SERVICE PROCEDURE

G-12503
MARCH 2012

SUBJECT: SAFETY RECALL
Bendix® ATR-6™ valve on certain CE bus models built 12/02/2010 thru 01/26/2012 with traction control or stability control.

FIGURE 1 - BENDIX® ATR-6™ TRACTION RELAY VALVE

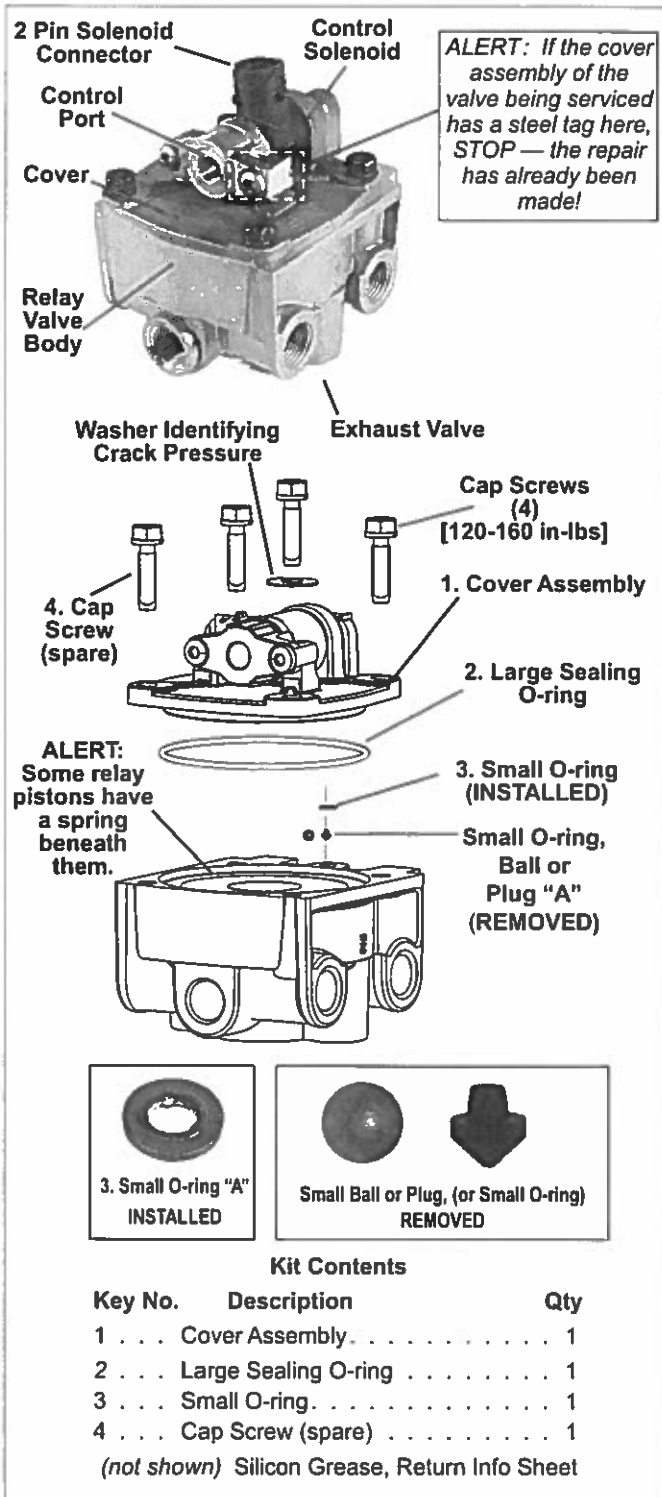
1. Verify that the Bendix® ATR-6™ valve does not have the steel tag (See Figure 1) that indicates it has already been serviced.
2. **Clean the valve and take care to avoid any contamination inside the valve during these procedures.**

6. • **Remove and discard the ball or plug** ("A" in Figure 1) from between the cover and the valve, OR,
• For ATR-6 valves that have not been serviced by a temporary disable kit, there will not be a ball or plug; **remove and discard the original small O-ring.**

7. Remove and discard the large sealing O-ring.
8. Grease and install the new large sealing O-ring (2) and the small O-ring (3) supplied, into the NEW valve cover.

9. Verify that no contamination has entered the valve. You **MUST** remove any debris inside. Use a clean shop cloth/shop air and use the supplied grease to replace any removed. With the replacement cover assembly (and mounting bracket) in the same orientation as the original, place the cover assembly into position over the valve body.

USE HAND-WRENCHES (ideally torque-wrenches) to re-install the four cap screws and I.D. washer in the cover and torque (in a cross-pattern) to 120-160 in-lbs. NOTE: All torques specified are assembly torques and can be expected to fall off slightly after assembly. Do not re-torque after the initial assembly torque falls off; **Do not over-tighten — overtightening could crack the cover or strip the threads.**
10. Reconnect the control air hose (and any other hoses removed) to the valve.
11. Reconnect the wire harness to the traction solenoid.
12. Repeat steps 1-11 where a second Bendix® ATR-6™ is present.
